WCAP-15831-P  
Project 694

May 17, 2004

Subject: Response to Clarification Request - WCAP-15831-P "WOG Risk Informed ATWS Assessment and Licensing Implementation Process"

Response to NRC's Request for Further Clarifications

**Table 4**  
**ATWS Case 1 Unfavorable Power (ANC Power – CPT Power) for the**  
**High Reactivity Core Model with Equilibrium Xenon and No Control Rod Insertion**

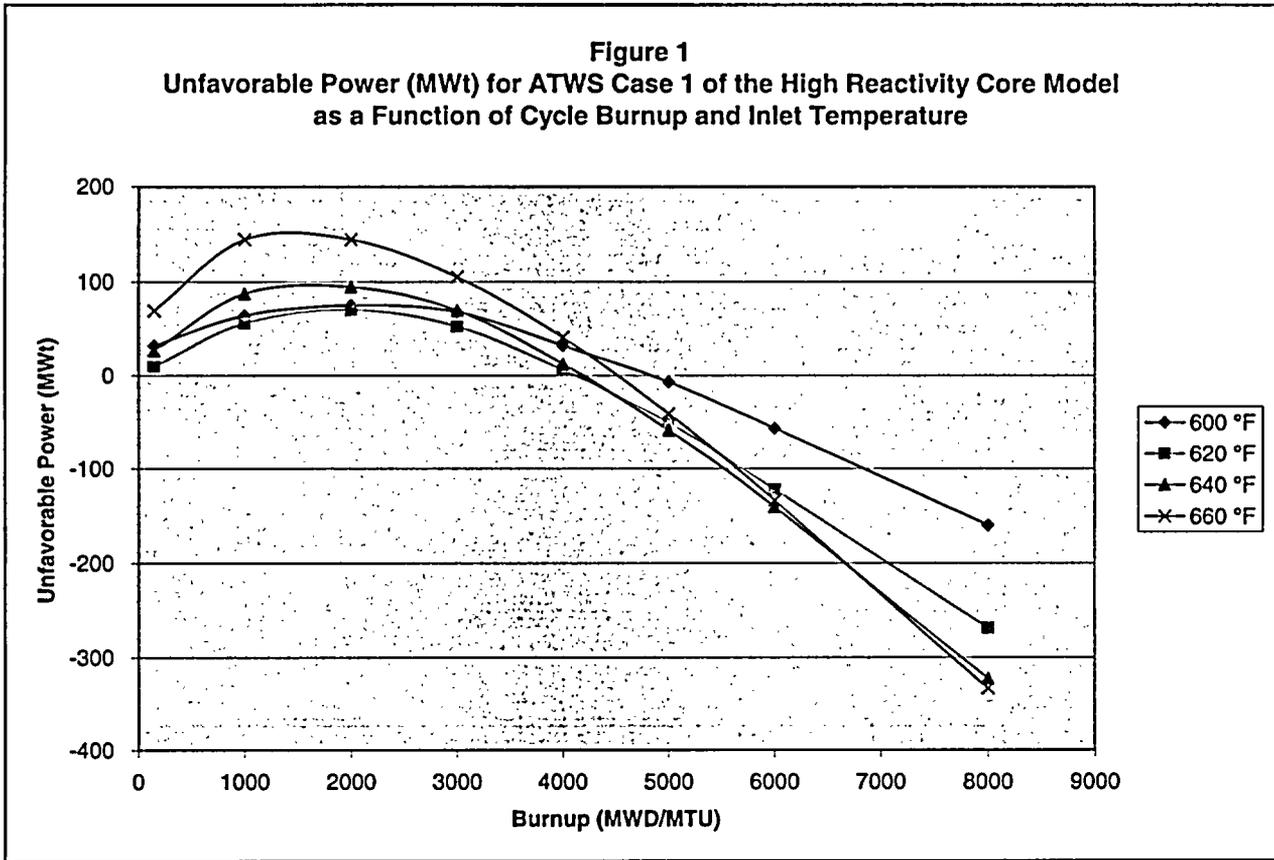
**Technical Clarification 5.d.** The CPT results are presented in Tables 4-1 and 4-2, but the TR does not provide a clear description of how these values are generated. For at least one representative point in the tables, please provide a detailed explanation of the methodology used to generate the CPT value. This should include the LOFTRAN generated plots for the key system parameter values used in the evaluation of CPT and a sample calculation demonstrating the method used to calculate the UETs provided in Section 4.2 of the TR. The explanation should include a detailed description of the ANC computer code model (e.g., noding, full core) and provide output plots for the key parameters generated by ANC. The WOG should also demonstrate how the ANC output is compared to the CPTs to determine UETs.

For each inlet temperature and burnup step, a parameter termed the “unfavorable power” is then calculated. This is simply the difference between the ANC critical power and the CPT power. These values are given in Table 4. Positive values indicate an unfavorable ATWS response since the ANC critical power is larger than the power level required to reach the peak pressure limit. Conversely, negative values indicate a favorable ATWS response since the ANC critical power is less than the power level required to reach the peak pressure limit. The values from Table 4 are plotted in Figure 1 (only values corresponding to burnups of up to 8000 MWD/MTU are plotted).

The UET is determined by the range of cycle burnups for which the unfavorable power is positive for any inlet temperature. As Figure 1 shows, the curve for 600 °F crosses the zero line at the largest burnup. This burnup is 4822 MWD/MTU, which corresponds to 110.1 EFPD. Since the UET starts at the beginning of the cycle (Figure 1 shows that BOL is unfavorable for all inlet temperatures), the total UET for this case is, therefore, 110.1 EFPD.
